SERVICE No. 1092B BULLETIN

Date: April 28, 2003 (S)

Service Bulletin No. 1092B corrects the aircraft effectivity list. SB 1092B supersedes SB 1092A. If SB 1092 or SB 1092A has been accomplished, SB 1092B is not required.

ENGINE MOUNT INSPECTION

Figure 1

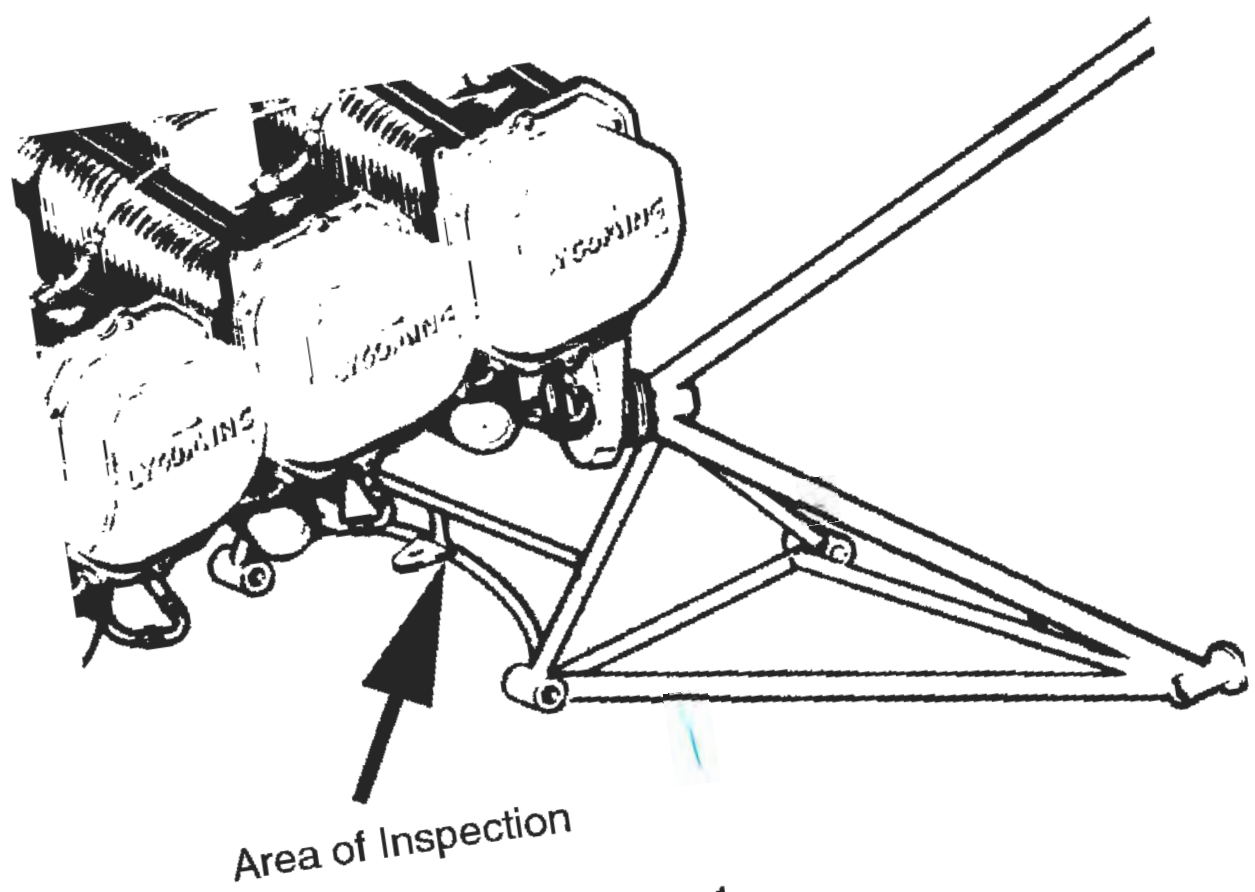
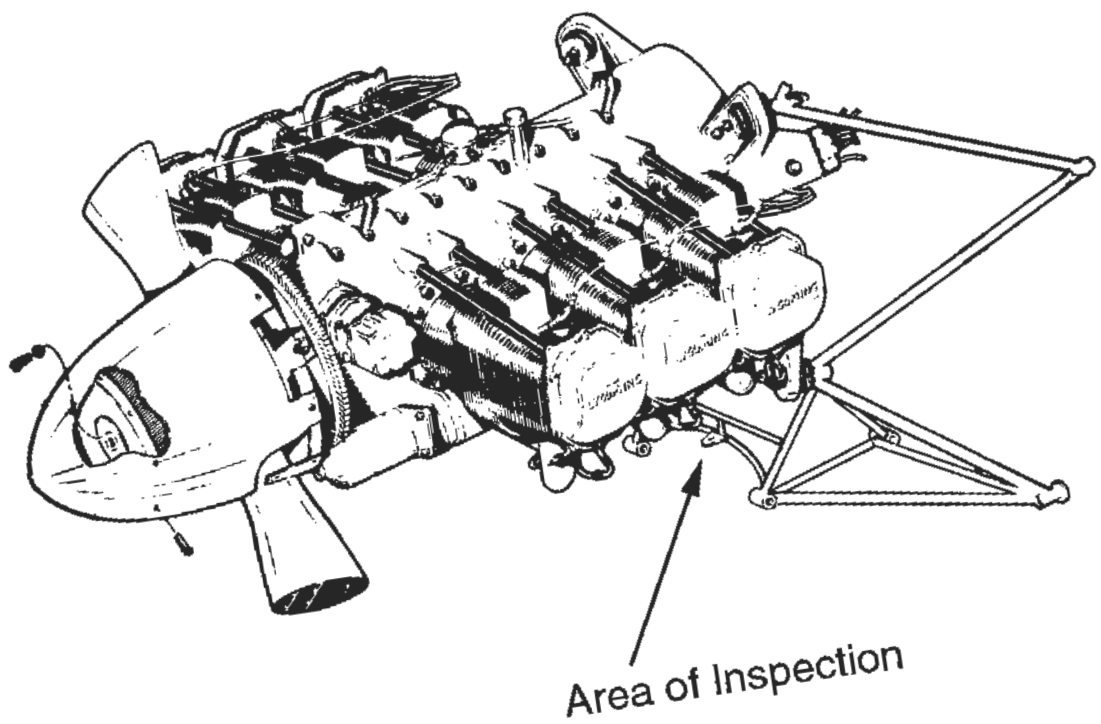
1. Inspect the engine mount, per AC 43.13-1B in the area indicated in Figure 1 for cracks. Pay particular attention to the weld joint between the short, interconnecting vertical-tube and the lower horizontal tube.
2. If a crack appears in the tube at any point, the engine mount must be repaired or replaced before further flight. The repair of the engine mount per Part II or the replacement of the engine mount with Piper part number 38729-21 or 38729-22 engine mounts constitute compliance with PART I and PART II of this Service Bulletin.
3. If no cracks are found, continue with repetitive one hundred (100) hours time in service inspection per the compliance time above.

Figure 2
Weld Repair Views

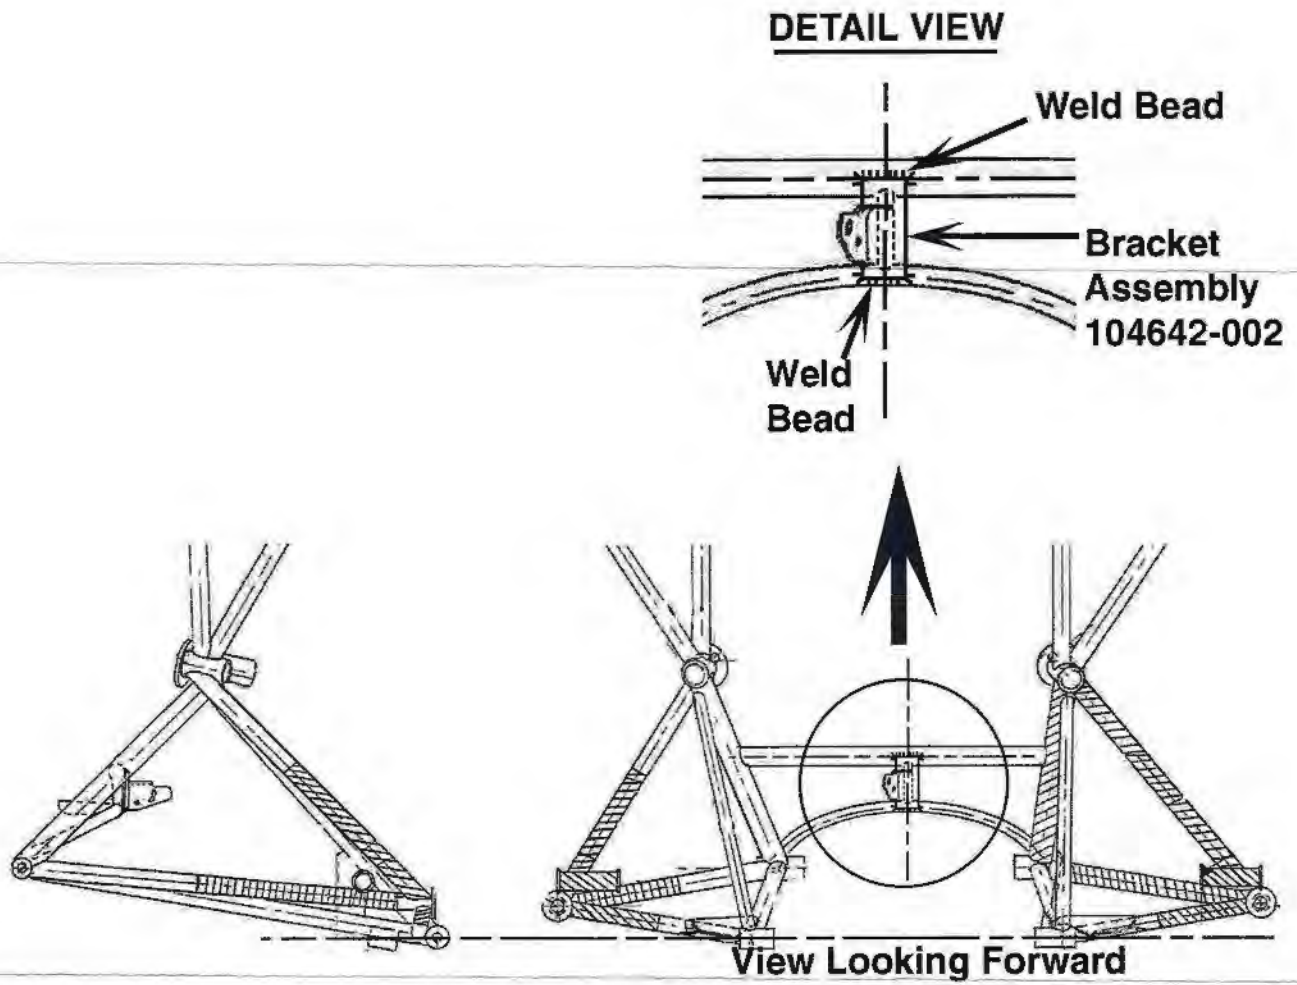
- 1.2 Repair the cracked tube by T.I.G. welding per AC43.13-1B procedures. All welding must be performed by a certified welder.
 - 1.3 Position the 104642-002 bracket assembly by aligning it on-center with the vertical interconnecting tube and centered between the horizontal tubes, as shown in Figure 2.

- 1.4 Attach the bracket assembly to the engine mount by T.I.G. welding per AC43.13-B along the top and bottom edges of the bracket as shown in Figure 2.
